Product Change Notification

Bourns® Model SRN8040 Semi-Shielded Power Inductor Series Change to Packaging Specification, Minimum Order Quantity and Multiple Ordering Quantities

Figure 1 - Current Carrier Specification

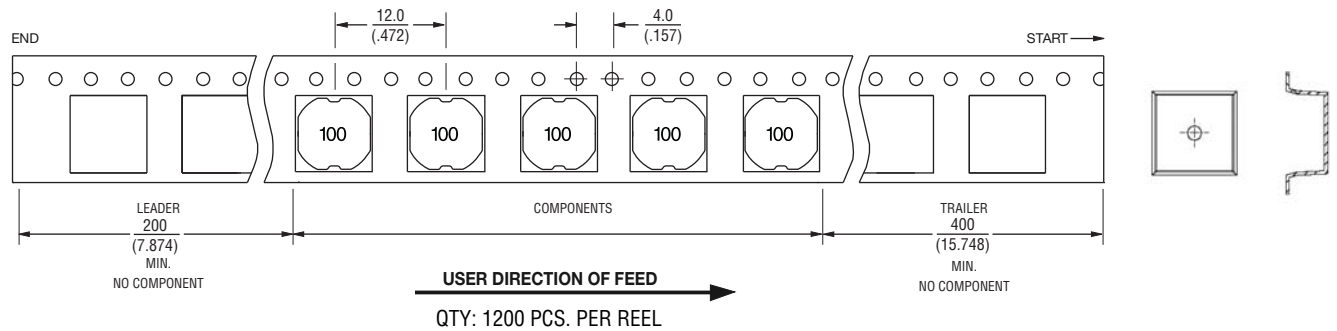
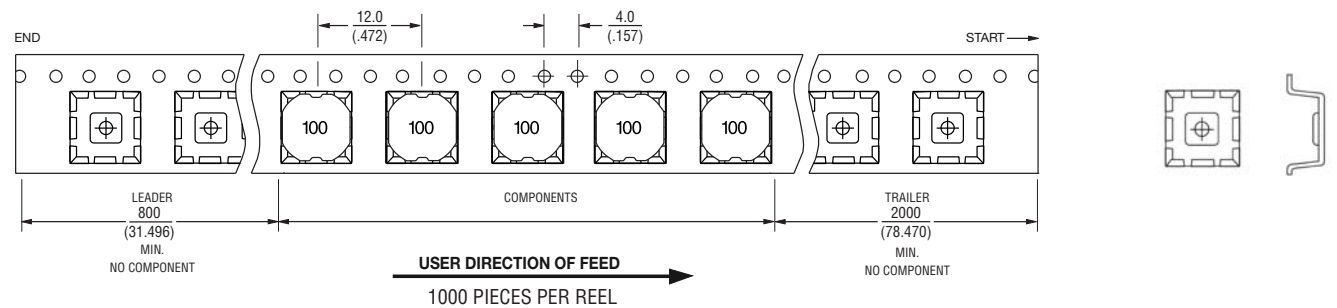
The packaging specification of the tape and reel carrier of the Model SRN8040 has been redesigned with embossment on the bottom and sides to provide shock absorption in order to help protect the inductor during shipping and handling. Along with this change, the tape leader, trailer and the number of inductors packaged per reel has been modified. Figures 1 and 2 highlight these changes. The MOQ and MULT ordering quantities of the Model SRN8040 Series have changed from 1200 pcs to 1000 pcs.

Figure 2 - Modified Carrier Specification
